REFERENCE COPY NONCONFORMANCE REPORT

1. ITEM DESCRIPTION BEAM ANGLES	2. PROJECT NO. 8031	12. REPORTED BY <i>M. G. ...</i>	DATE 10-22-76
3. SERIAL NUMBER 232B7 + 232B9	8. ITEM LOCATION <i>See below AREA 19, elev. 253'</i>	13. VALIDATED BY <i>T. H. Brown</i>	DATE 10-22-76
4. PURCHASE ORDER NO. N/A	9. STARTUP SYSTEM NO. N/A	14. REPLACEMENT PART NO.	REASON X
5. CONTRACTOR/LOCATION N/A	10. QC FIELD INSPECTION PLAN NO. C-201-W-1-7 + C-201-W-1-8	15. REPLACEMENT SERIAL NO.	DATE 11-26-76
11. ASME CODE ITEM	<input type="checkbox"/> YES <input checked="" type="checkbox"/> NO	16. SOURCE CONSTRUCTION	DATE 11-17-76
18. ROUTING INSTRUCTIONS:	<input checked="" type="checkbox"/> ROUTE TO FIELD ENGINEERING	<input type="checkbox"/> ROUTE TO MATERIAL SUPERVISOR	DATE 12-2-76

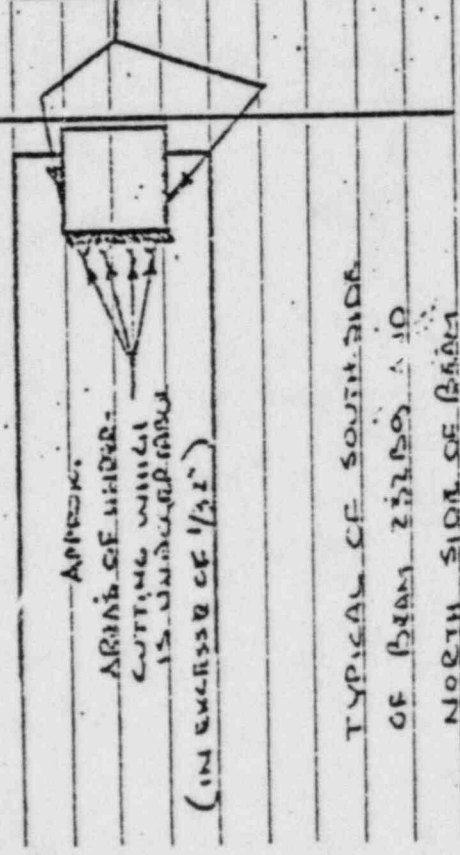
WHILE REPAIRING THE TWO BEAMS, COPES WERE MADE INTO THE BOTTOM FLANGES AS SHOWN.

FIELD RECOMMENDATION TO LEAVE BEAMS AS IS.

REPAIR: rationale: proposed repair procedure will not impair structural capacity of steel. Copies required to make repair may be left as is.

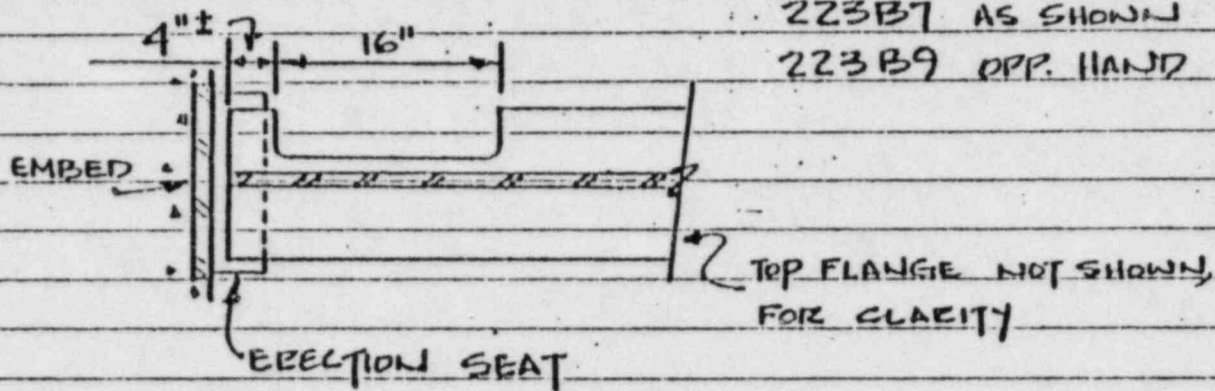
Block #19 CONT. AND UNACCEPTABLE DUE TO EXCESSIVE UNDERCUTTING AND INCOMPLETE WELDING OF THE CONNECTION ANGLE TO THE BEAM WEB. THIS IS CONTRARY TO THE 1970 EDITION OF THE AISC CODE - PART 4 REVISED 6-73 AND AWS D1.1-72, RI-73 AND RB-74 EDITIONS.

AREAS UNDER WELDS IS INCOMPLETE AND OUT OF SPKS. AS OUTLINED IN THE REQUIREMENTS SUPPLIED DATA AND THE AISC REQUIREMENTS.

APPROX. 1 PASS (1/2" OF WELD) VS. REQ'D 7/16" WELD

TYPICAL OF SOUTH ENDS OF BEAM ZHODS AND NORTH ENDS OF BEAM ZHODS
